## APPLICATION FOR CERTIFICATE OF APPROPRIATENESS HISTORIC CONSERVATION BOARD PUBLIC HEARING STAFF REPORT

APPLICATION #: ZH2017207/COA2017086  
APPLICANT: MSA Architects  
OWNER: OTR Holdings LLC  
ADDRESS: **1536-1540 Race Street**  
PARCELS: 081-0004-0517  
ZONING: CC-P  
OVERLAYS: Over-the-Rhine Historic District  
COMMUNITY: Over the Rhine  
REPORT DATE: January 10, 2018 updated February 12, 2018, updated March 28, 2018  
HEARING DATE: February 26, 2018  
STAFF REVIEW: Beth Johnson, Urban Conservator

DRAWING TITLE  
**PROPOSED ELEVATIONS**

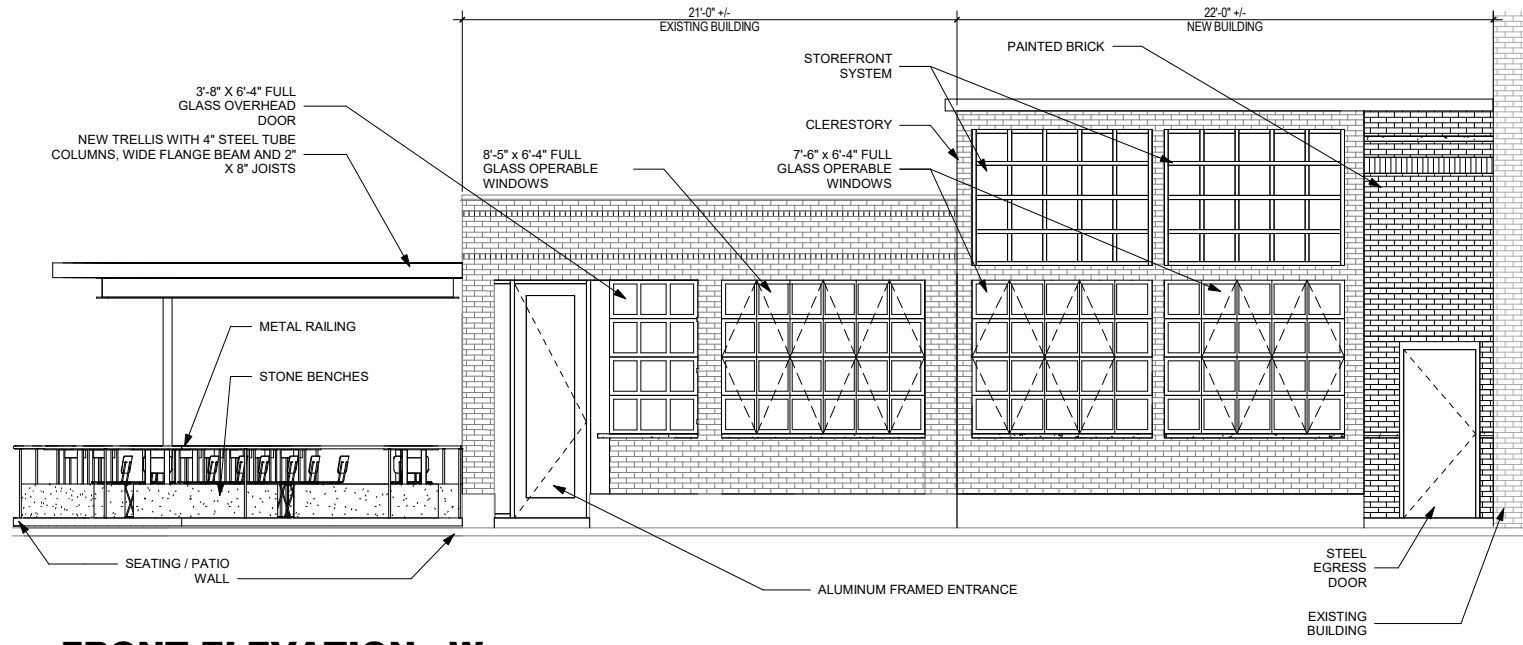
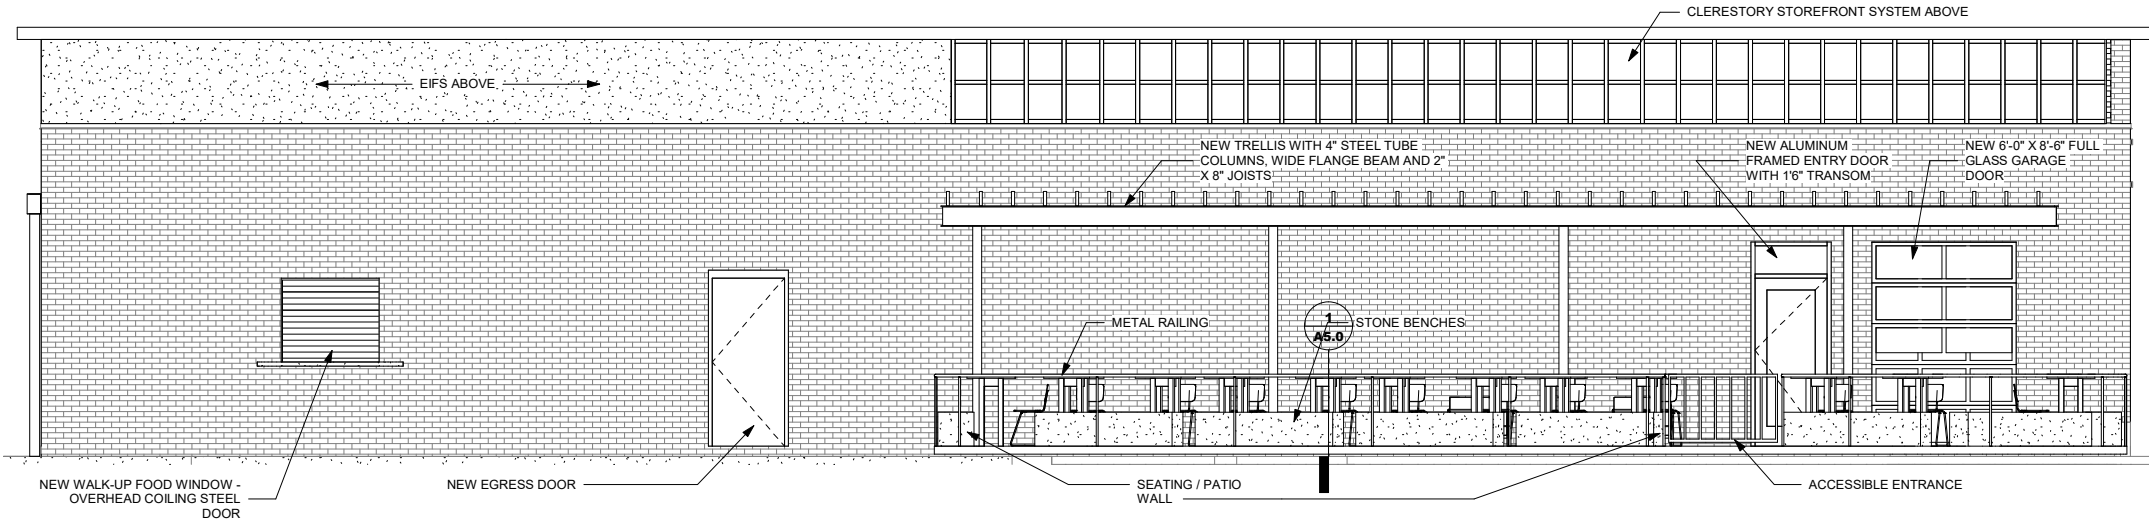
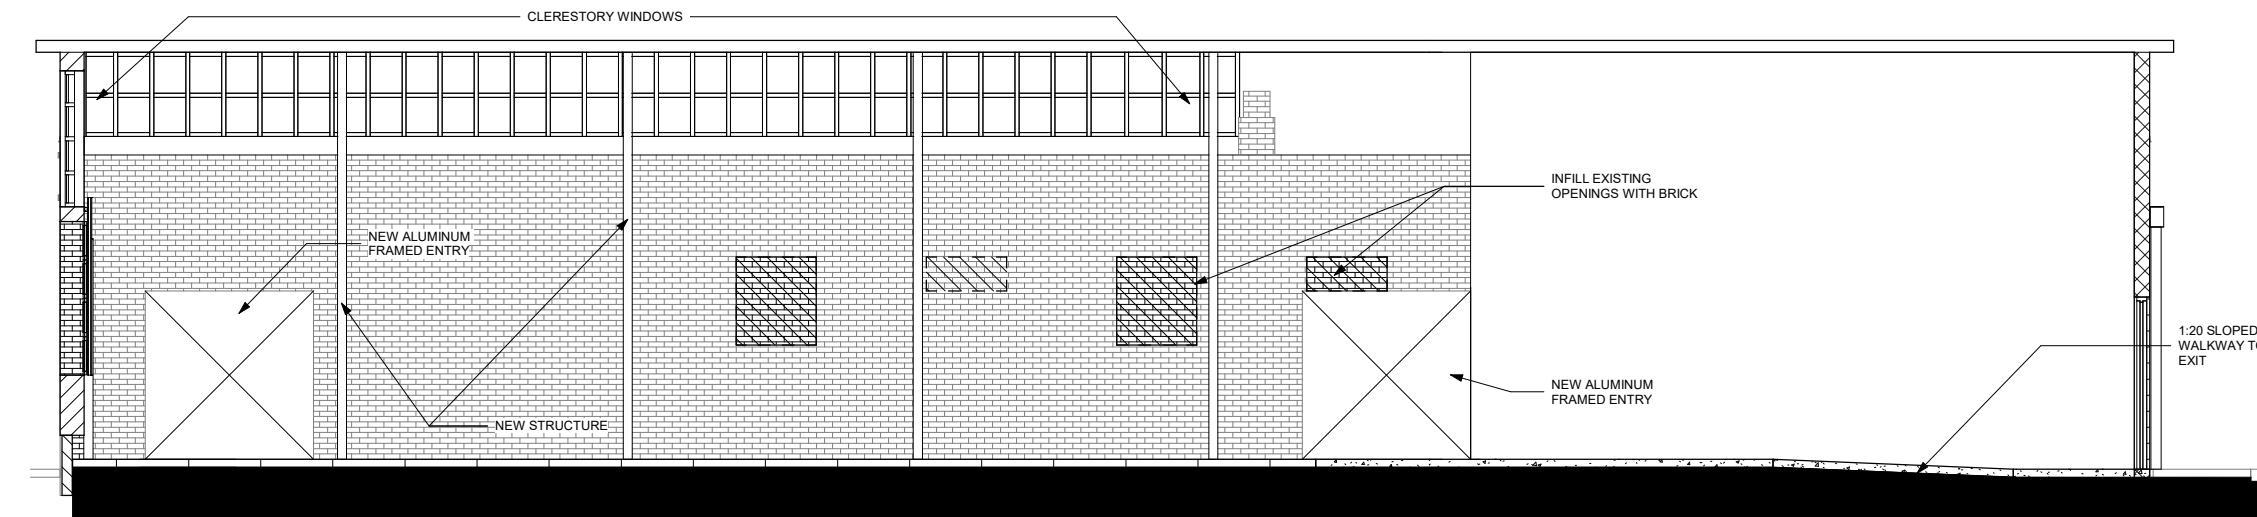
*The height is appropriate to the site and the area. The building is a one story building, but with an added ½ clearstory. This provides a transition between the 1-story connected building and the 2 story building to the south.*

*Both the north and south patios are using existing paved area. Both patios add a pergola. The south patio will not be visible from the street and the north patio will be highly visible from the street, but the design of an open area with a small pergola will not detract or create an adverse effect on the historic fabric. The patio is mostly bordered by Liberty Street and will create a transition space from the public realm of the street to the business. The pergola is a simple design with wood and an I-beam. As the building is a small utilitarian building the simple design is an appropriate design for the building.*
